Re: First Submission Review – Windler Sign Site Plan Amendment
Case Number: 2023-4014-01

PLANNING DEPARTMENT COMMENTS

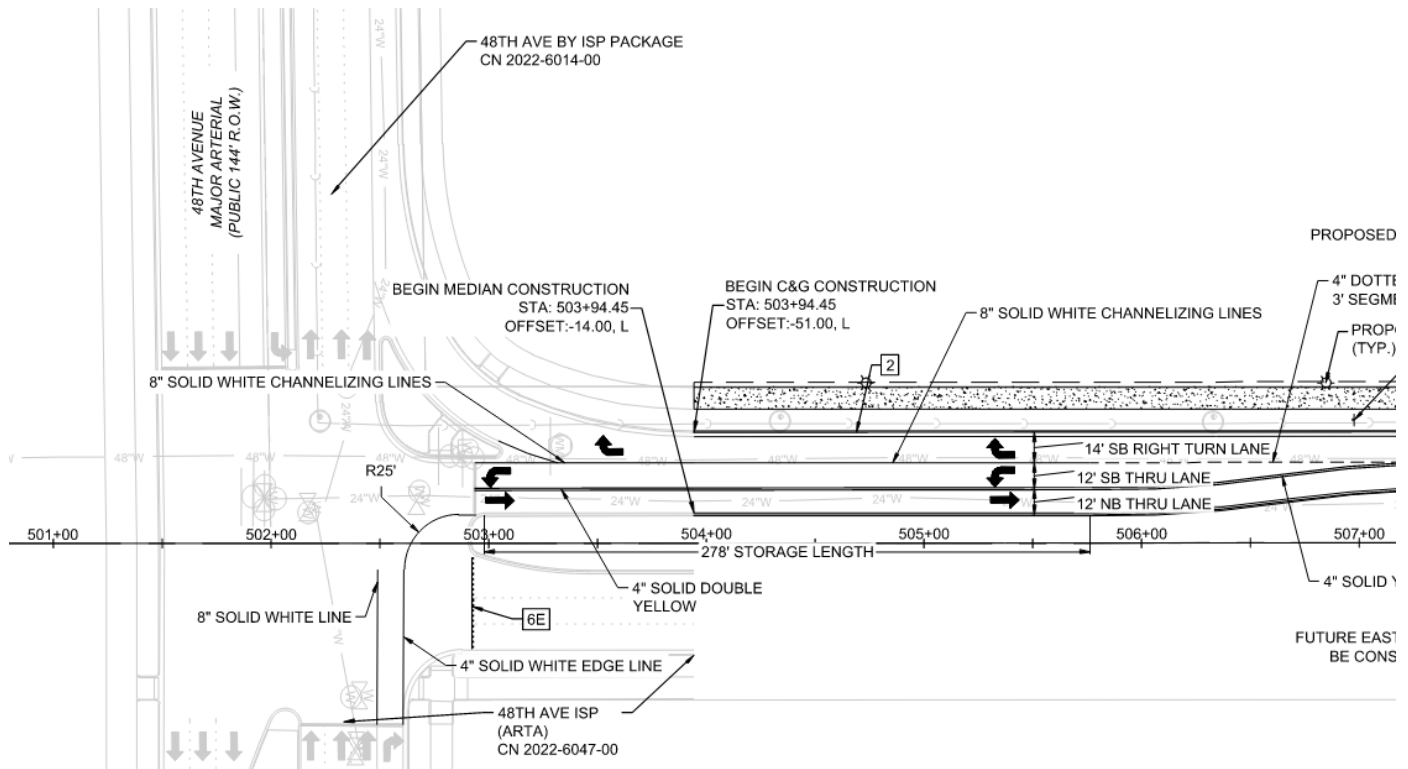
2A. Add sight triangles at intersections

Civitas: Site triangle added at 48th and Tibet.

At 48th and Harvest: Harvest has a dedicated right turn. Our site doesn't have a sight line within Windler's boundary at Harvest/48th. Please find clip below.
